# Jonah Center for Earth and Art Walking Trail and Kayak Launch Middletown, Connecticut

**Environmental Review Team Report**

**City of Middletown and the Jonah  
Center for Earth and Art  
Middletown, Connecticut**

**May 2006**

Figure 2 - The drainage swale depicted above empties into the forested wetland of this floodplain. The stream was actively flowing, not frozen.

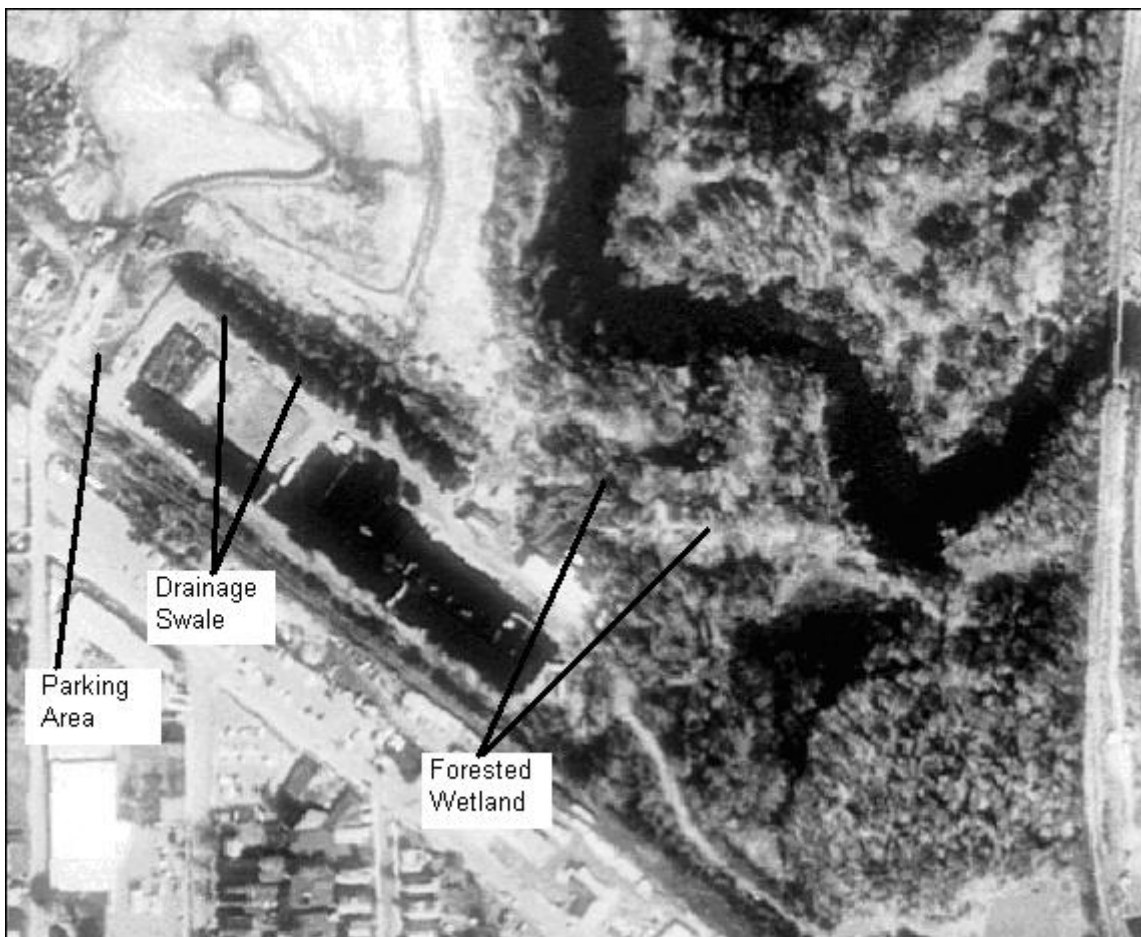
Of the wetland areas the Team visited that were likely to be impacted by any future activity, both are waterside locations which are likely prone to various elevations of flooding. The first of these is the forested wetlands labeled in Figure 2. There was some snow on the ground here, but as can be seen in Figure 3, there were also areas that were snow free and the ground was exposed.

Figure 5 - this 2004 image shows the landfill site in its entirety with a closeup of the west side indentation. The dark color, single lane road is visible to the right of the tree line in the right hand image.

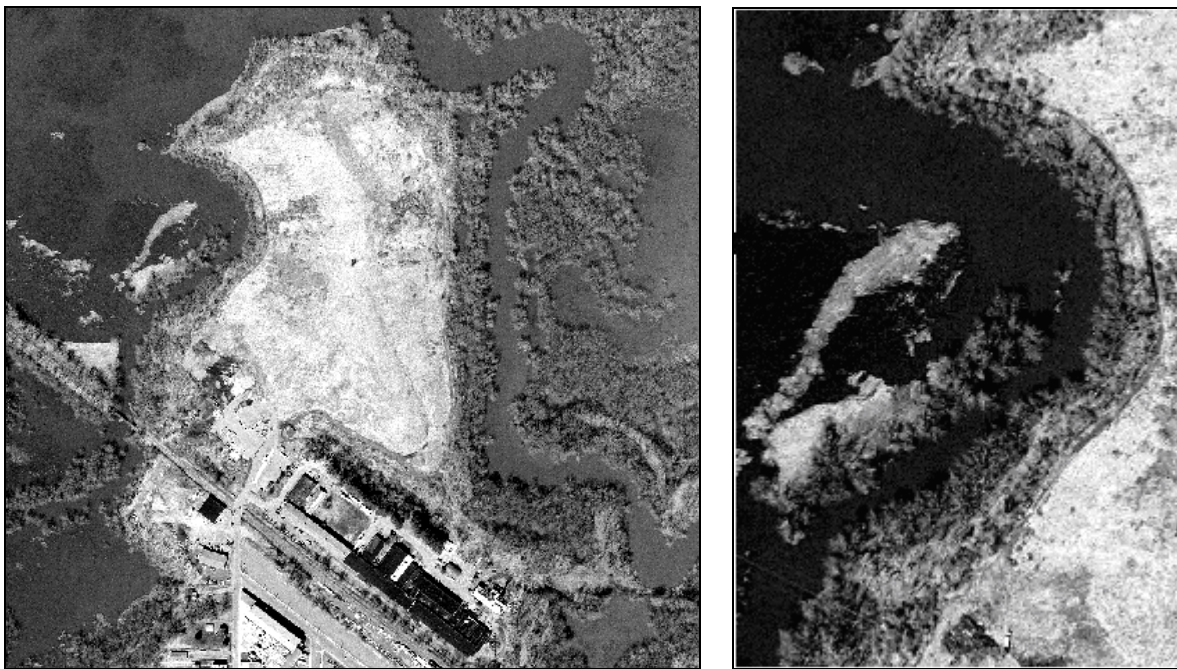
The Coginchaug River abuts the property along the west side as can be seen below in this 2004 image of the area (Figure 5). It is clear from the photograph that much of this floodplain was in flood condition when this photo was taken. The half circle, arc-like indentation along the west side of the peninsula is paralleled by a single lane road, just to the east of the tree line. This road would be the general vehicle access to the rear carry-in launch site. The image also provides the opportunity to visualize the variable 60 - 80 foot wide riparian buffer that lies between the river and the road.

Any approach to the watercourse should be located as close to the level of the water as possible. The Team saw that the Mattabesset forms a "W" in its meandering. The two bottom points of the "W" are undercut by the river and exhibit the longest drop to the water from the shore. The indentation between the two lower points of the "W" would have the most level land-to-water access. One of the steep drops to the water at the undercut areas is seen in Figure 5.
